# Access Compliance Report

## Public Rights-of-Way

Intersection ID: 45517	Main Street: BUGGY_HORSE_RD	Cross Street: MEADOW_BOTTOM_RD	Location: S
ADA ID: 18FDD3B7EB43	Ramp Type: PerpDiag	Initial Pass/Fail: Fail	Overall Compliance: No
Severity Score: 42.5			
Codes/Mitigation Info/Possible Solution		Field Measurements/Component Compliance

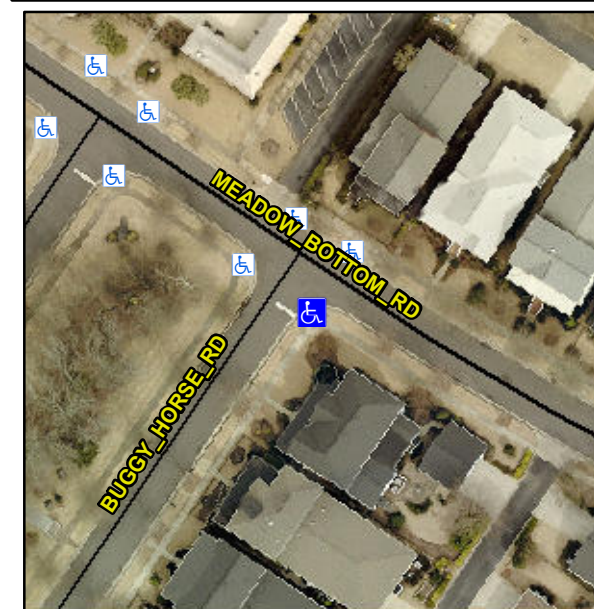
**Not Found, R304.5.1, R304.2.2**

Compliance	Description	Data	Compliance	Description	Data
N/A	Ramp Length (in)	73.0	No	Ramp Slope (%)	12.4
No	Ramp Width (in)	32.0	Yes	Ramp XSlope (%)	0.9
N/A	Flare Type LT	N/A	N/A	Flare Type RT	N/A
N/A	Flare Slope LT (%)	N/A	N/A	Flare Slope RT (%)	N/A
N/A	Flare Traversable LT?	N/A	N/A	Flare Traversable RT?	N/A
N/A	Landing Length (in)	N/A	N/A	DWS Provided?	N/A
N/A	Landing Width (in)	N/A	N/A	DWS Contrast?	N/A
N/A	Landing Slope (%)	N/A	N/A	DWS Length (in)	N/A
N/A	Landing X Slope (%)	N/A	N/A	DWS Full Width?	N/A
N/A	Landing Curb? (Y/N)	N/A	N/A	DWS Offset (in)	N/A
N/A	Shared Landing?	N/A			
N/A	Gutter Ponding?	N/A	N/A	Gutter Slope (%)	N/A
N/A	Gutter Lip Ht (in)	N/A	N/A	Gutter X Slope (%)	N/A
N/A	Painted X Walk1?	No	N/A	Painted X Walk2?	No
	X Walk 1 Direction	To NE		X Walk 2 Direction	To NW
N/A	X Walk 1 Width (in)	N/A	N/A	X Walk 2 Width (in)	N/A
	X Walk 1 Slope (%)	6.6		X Walk 2 Slope (%)	5.4
	X Walk 1 X Slope (%)	2.5		X Walk 2 X Slope (%)	3.4

N/A	Ramp inside XWalk1?	N/A	N/A	Ramp inside XWalk2?	N/A
	Road Slope (%)	0.7	N/A	Clear Space?	N/A
	Road X Slope (%)	5.9	N/A	Clear Space to XWalk (in)	N/A
N/A	Any Obstructions?	N/A	N/A	Storm Grate/Utility Hazard?	N/A
	Obstruction Type			Storm Grate/Utility Type	
		N/A			N/A
		Yes		Surface Condition? (G/P)	Good

**Remove & Replace Curb Ramp With Two New Directional Ramps or Equivalent.**
